POLARIS ENGINEERING & SURVEYING, INC.
34600 CHARDON ROAD
SUITE D
WILLOUGHBY HILLS, OH 44094
(440) 944-4433
(440) 944-3722 (Fax)
www.polaris-es.com

SITE PLAN FOR:
PPN: 04-A-053-A-00-038-0
HARPER STREET
VILLAGE OF PERRY - LAKE COUNTY - OHIO

DATE: 1/13/15
SCALE: HOR. 1"=20'
VERT. N/A
FILENAME: Site Plan
FOLDER: Site Plan
DRAWN BY: DER

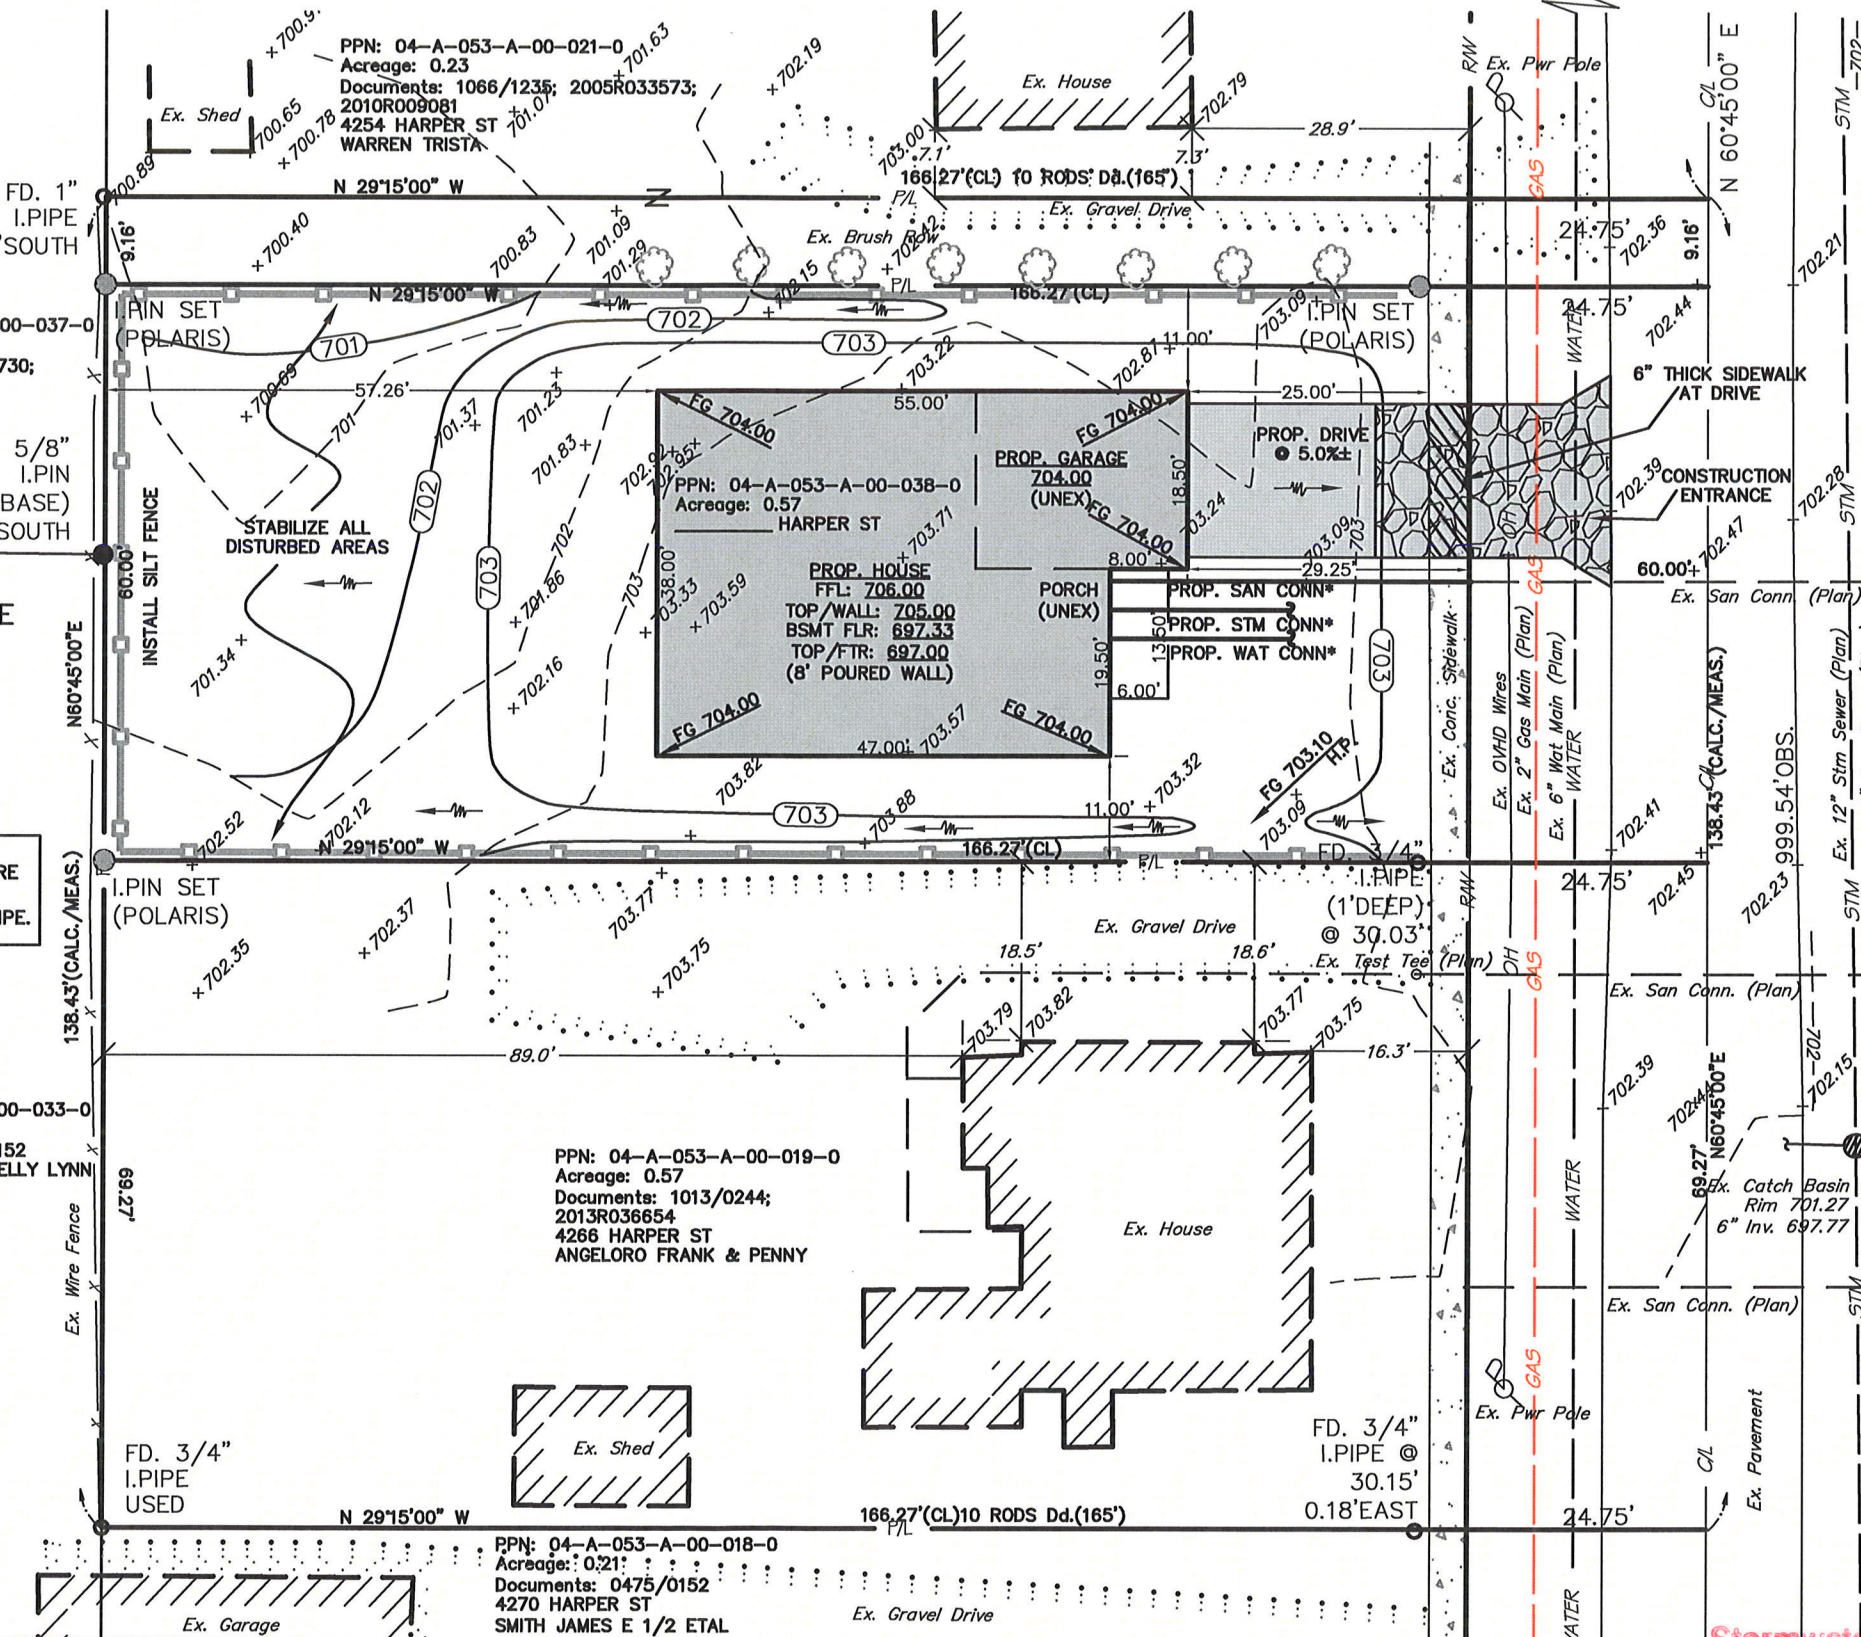
Stormwater Management Plan
Approved as shown and/or noted
JAMES R. ...
County Drainage Engineer
By *GJH* Date *1/27/2015*
Lower PG to 703.5
